## **ADDENDUM NO. 01**

**ITB-CD-CM-14-11**

### **Holland Park Improvements**

**SUBJECT: Clarifications/Modifications/Bidder Questions**

DRAWING:  
**E-2A**

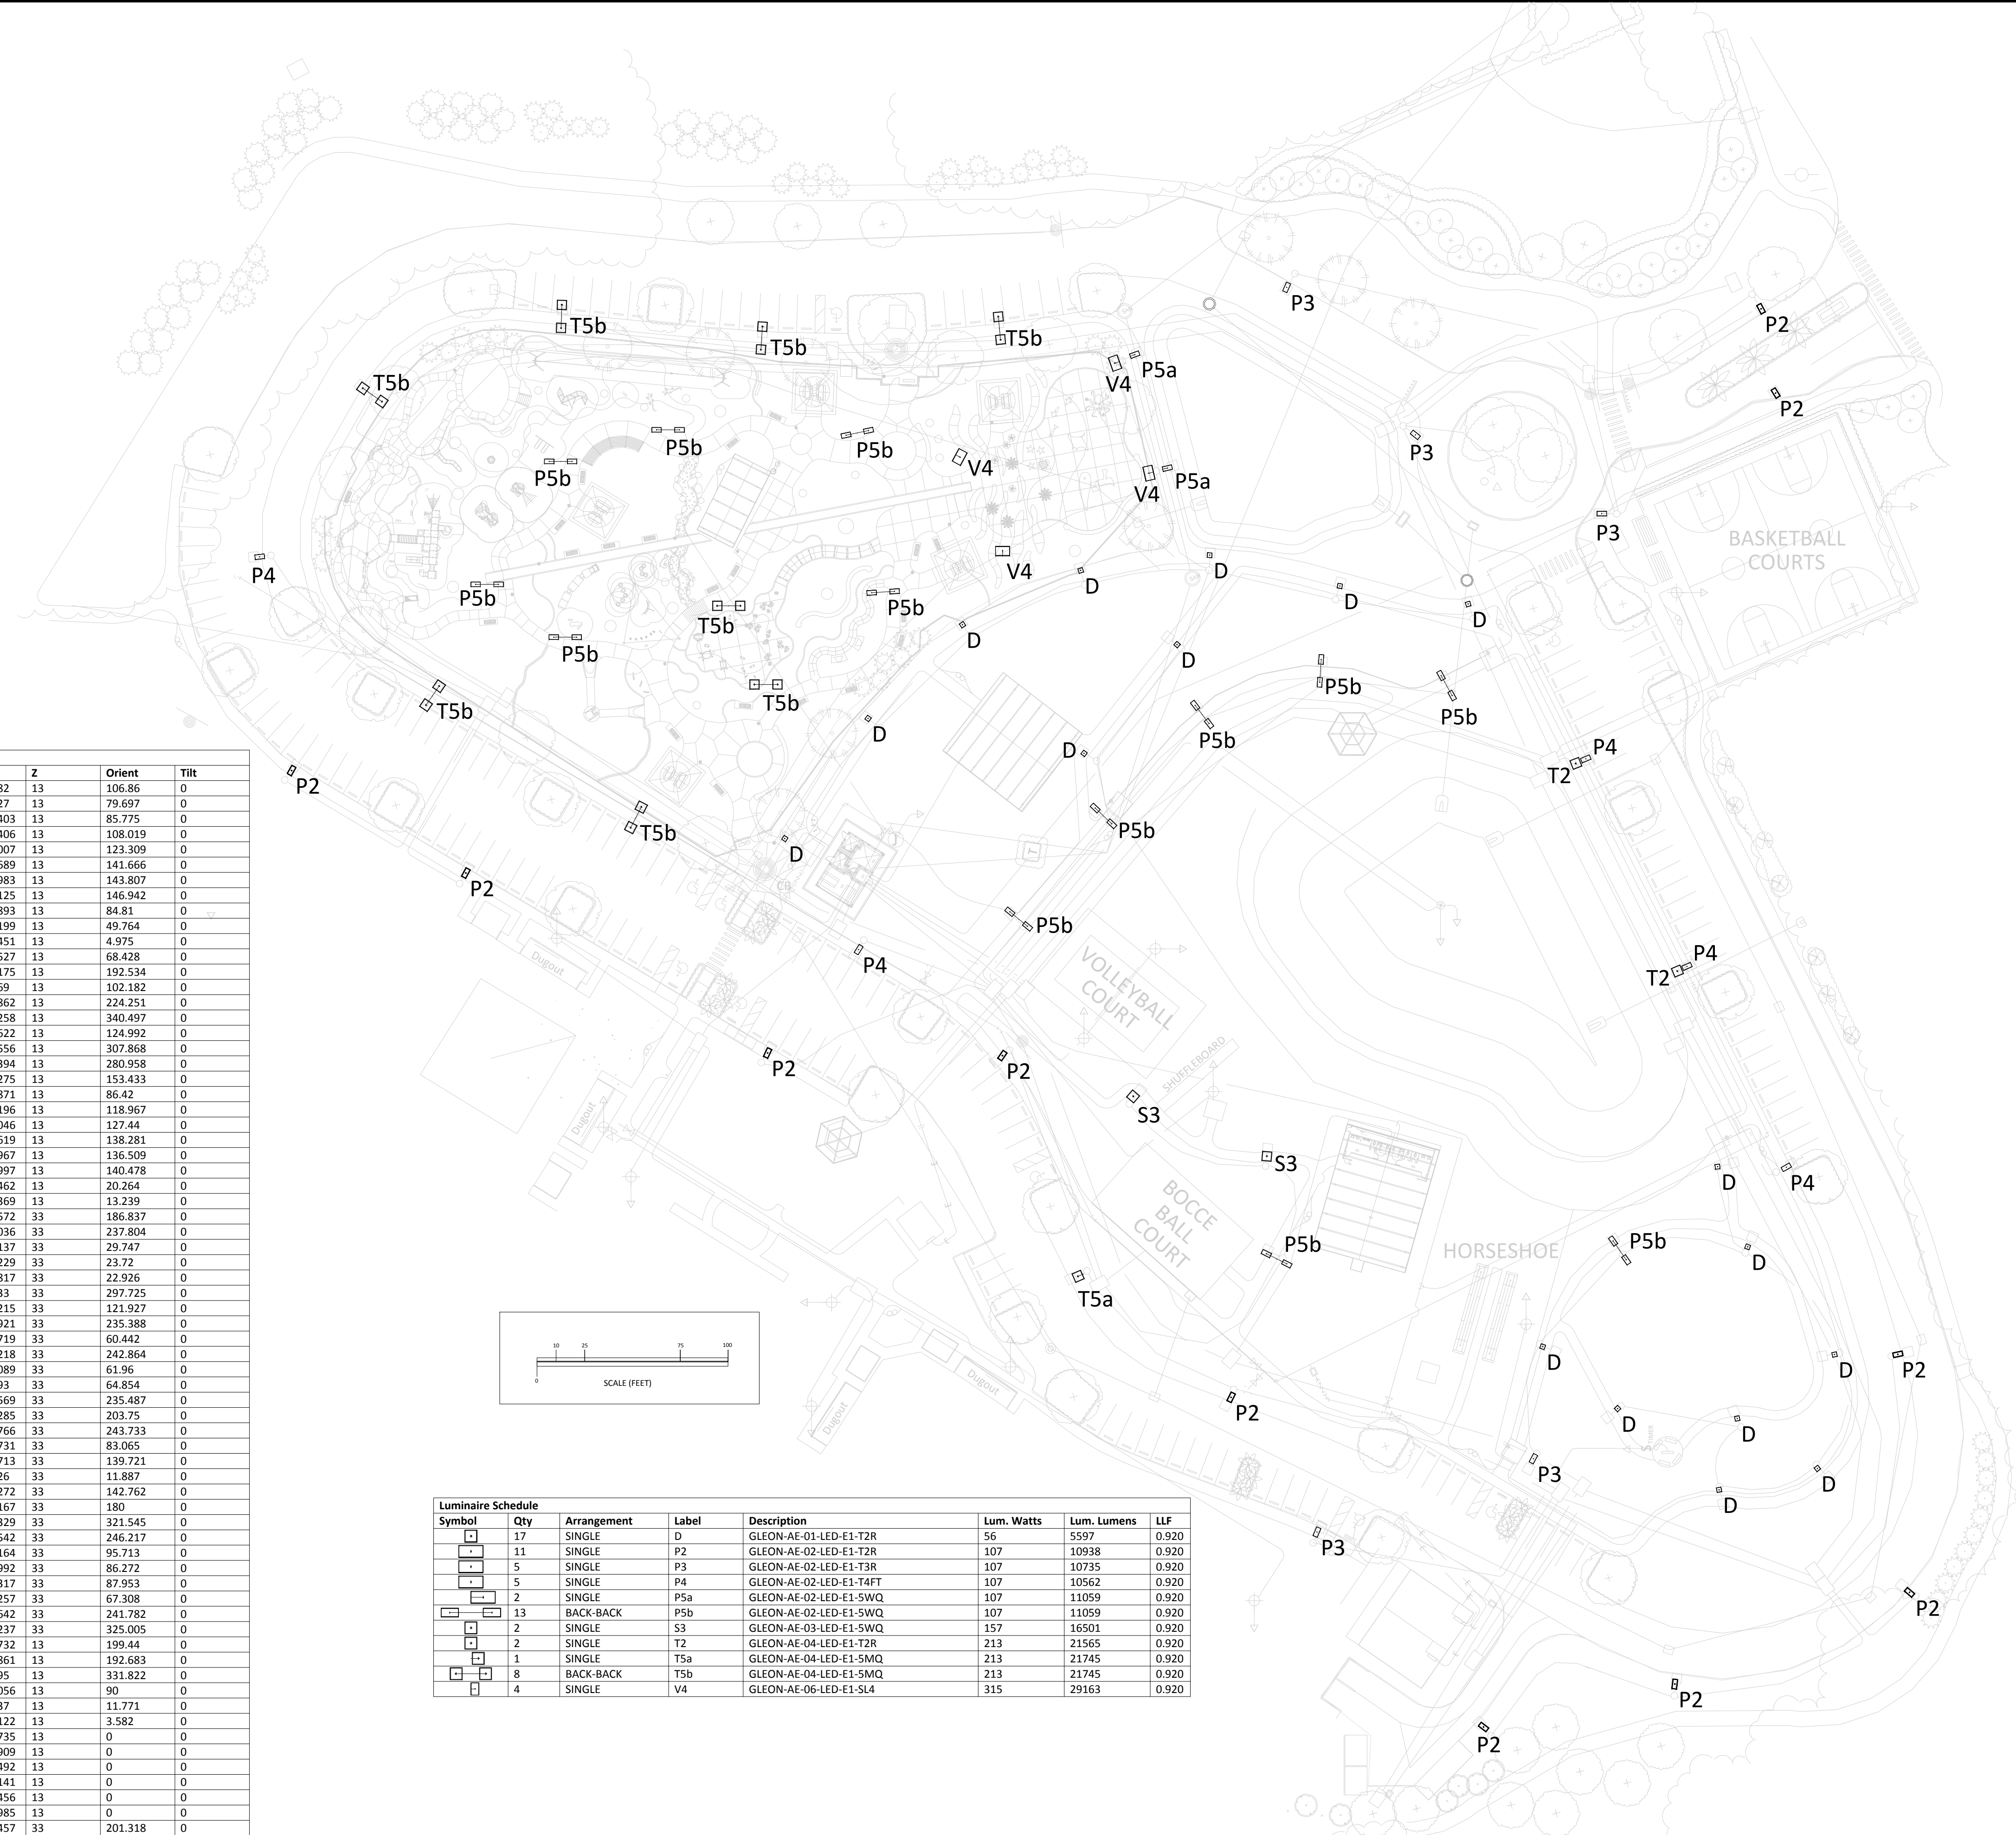
Q9. Sheet E-2 Site Plan New – Fixture types “A”, “D”, “E”, “F” and “G”:

**A.9 Delete fixture types “A”, “D”, “E”, “F” and “G” shown on Sheet E-2. Utilize fixture types shown on Sheet E-2A in lieu of E-2. Pole locations remain the same.**

Q25. Sheet E-4 Schedules – Lighting Fixture Schedule, fixture types “A”, “D”, “E”, “F” and “G”:

**A.25 Delete fixture types “A”, “D”, “E”, “F” and “G” shown in Fixture Schedule. Utilize Fixture types shown in Fixture Schedule on Sheet E-2A. All other fixture types remain the same unless noted otherwise.**
